## **Drainage Letter**

# Reigning Hope Indoor Arena

May 9, 2019

Add PCD File No. PPR1935

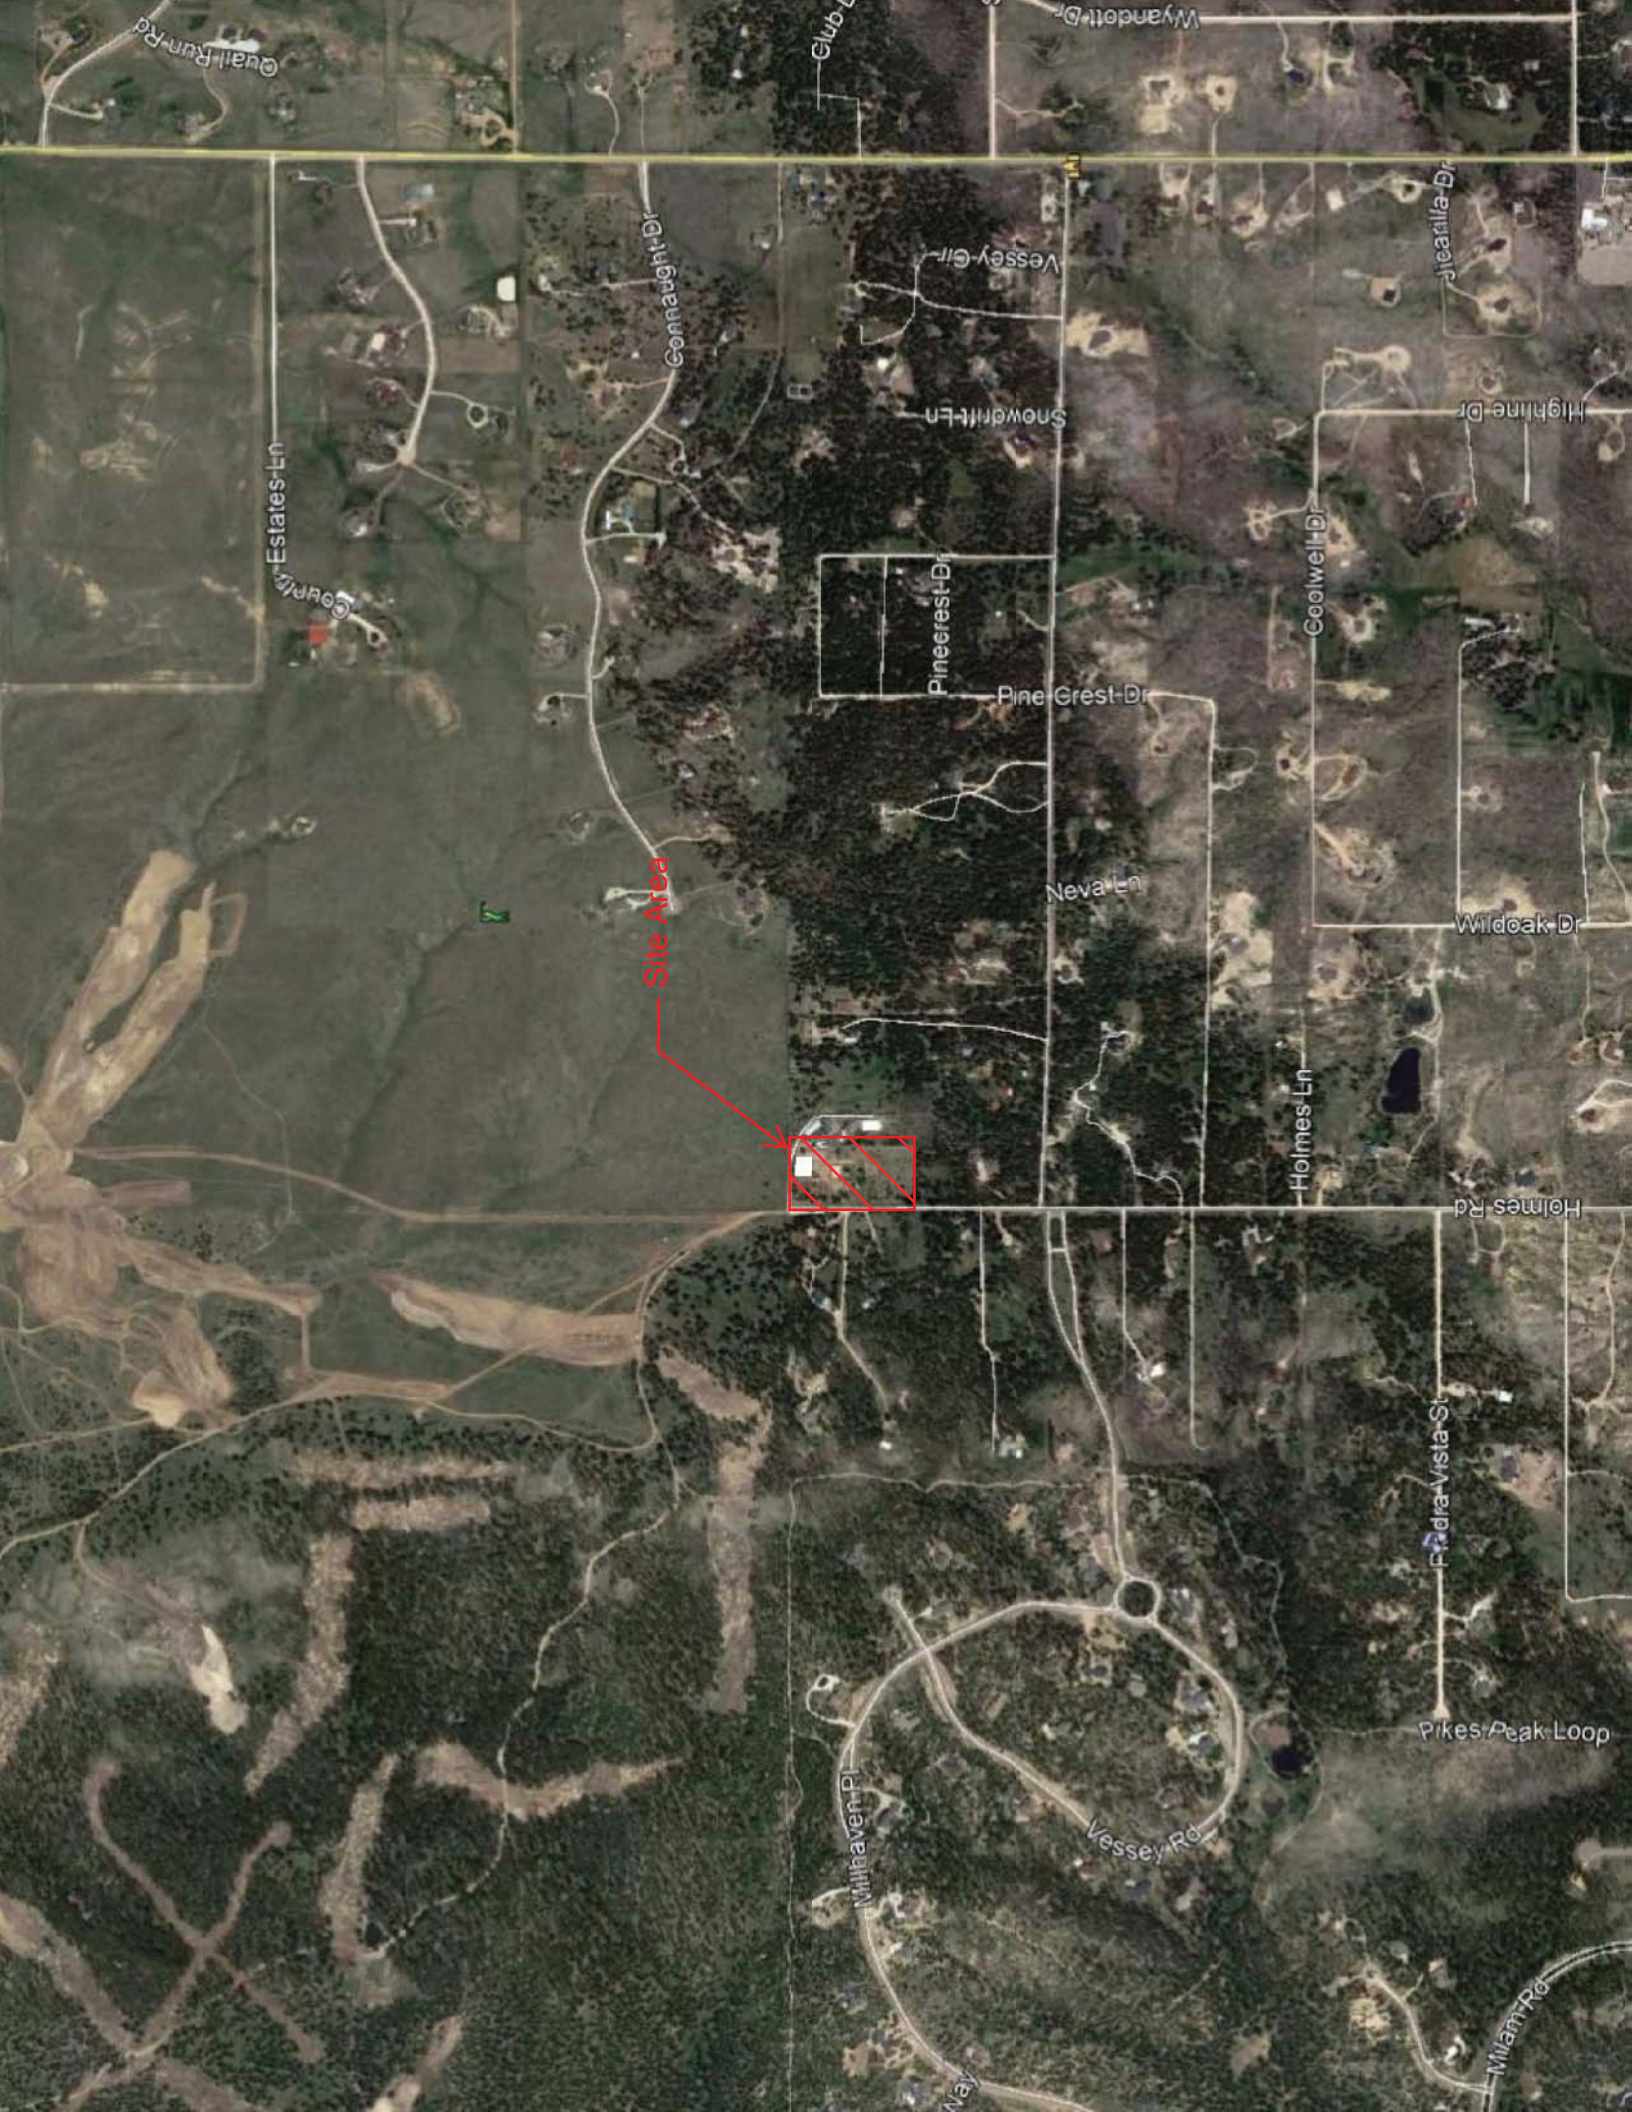
Please indicate in the report whether or not there will be any adverse affects to the surrounding or downstream properties due to this development.

please see comments in the proposed conditions calculations.

Please include the evaluation of the 4-step process per ECM Section I.7.2.
